Access Compliance Report

Public Rights-of-Way

Intersection ID: 47576	Main Street: BARRANDS_LN	Cross Street: SEDGEBURN_DR	Location: NW
ADA ID: 0F2503A3C75E	Ramp Type: PerpDiag	Initial Pass/Fail: Fail	Overall Compliance: No
Severity Score: 12.5			
Codes/Mitigation Info/Possible Solution		Field Measurements/Component Compliance

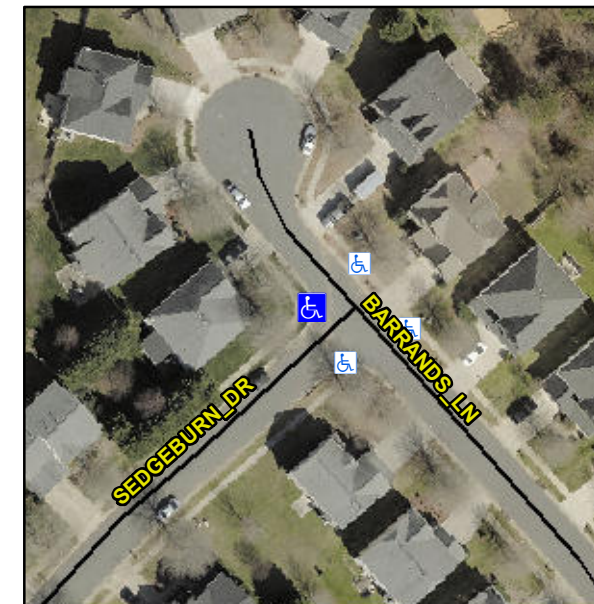
R304.2.2

Compliance	Description	Data	Compliance	Description	Data
N/A	Ramp Length (in)	48.0	No	Ramp Slope (%)	8.6
Yes	Ramp Width (in)	48.0	Yes	Ramp XSlope (%)	1.3
N/A	Flare Type LT	N/A	N/A	Flare Type RT	N/A
N/A	Flare Slope LT (%)	N/A	N/A	Flare Slope RT (%)	N/A
N/A	Flare Traversable LT?	N/A	N/A	Flare Traversable RT?	N/A
N/A	Landing Length (in)	N/A	N/A	DWS Provided?	N/A
N/A	Landing Width (in)	N/A	N/A	DWS Contrast?	N/A
N/A	Landing Slope (%)	N/A	N/A	DWS Length (in)	N/A
N/A	Landing X Slope (%)	N/A	N/A	DWS Full Width?	N/A
N/A	Landing Curb? (Y/N)	N/A	N/A	DWS Offset (in)	N/A
N/A	Shared Landing?	N/A			
N/A	Gutter Ponding?	N/A	N/A	Gutter Slope (%)	N/A
N/A	Gutter Lip Ht (in)	N/A	N/A	Gutter X Slope (%)	N/A
N/A	Painted X Walk1?	No	N/A	Painted X Walk2?	No
	X Walk 1 Direction	To SE		X Walk 2 Direction	To NE
N/A	X Walk 1 Width (in)	N/A	N/A	X Walk 2 Width (in)	N/A
	X Walk 1 Slope (%)	1.3		X Walk 2 Slope (%)	0.8
	X Walk 1 X Slope (%)	0.8		X Walk 2 X Slope (%)	0.1

Remove & Replace Curb Ramp With Two New Directional Ramps or Equivalent.
